Bulletin No.: 15168A
Date: May 2015

Recall Bulletin

SUBJECT: Loss of Electric Power Steering Assist

MODELS: 2015 Buick Encore
2015 Chevrolet Trax

Location of steering column lot number

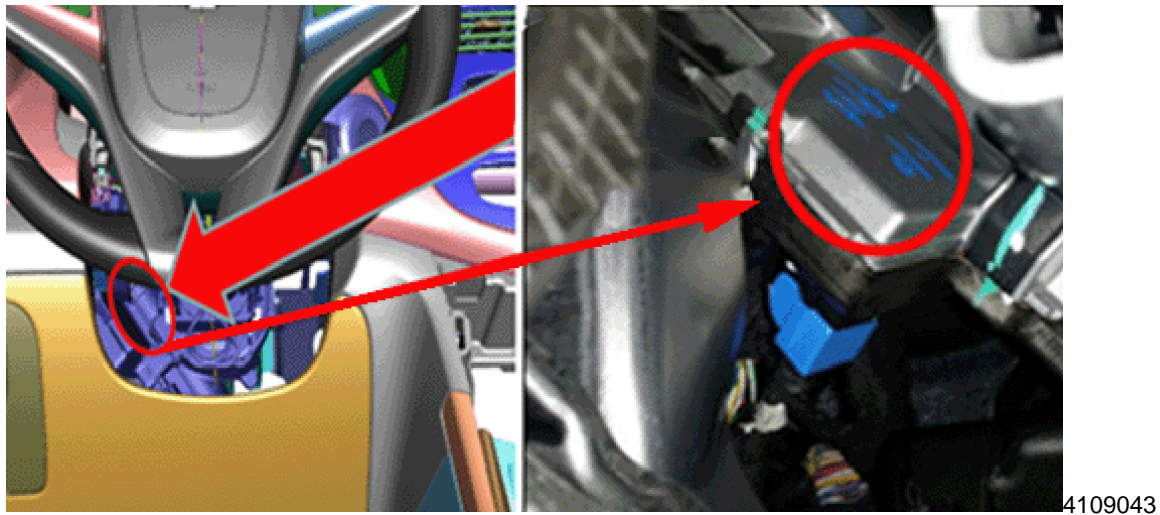
8. Check the housing LOT number.

NOTE: If the LOT number is illegible, or not readable, replace steering column.

- 9. A part with a LOT number (1) above 1200 (**including 1200, and up to and including 1600**) is **not OK** and must be replaced with a new steering column.
- 10. **If the LOT number is 1199 or less, then the part is OK** and the steering column does not need to be replaced. Do not go to the next step. Re-assemble parts in reverse order.
- 11. If the steering column has failed inspection, it will be necessary to replace the column. Refer to *Steering Column Replacement* in SI.
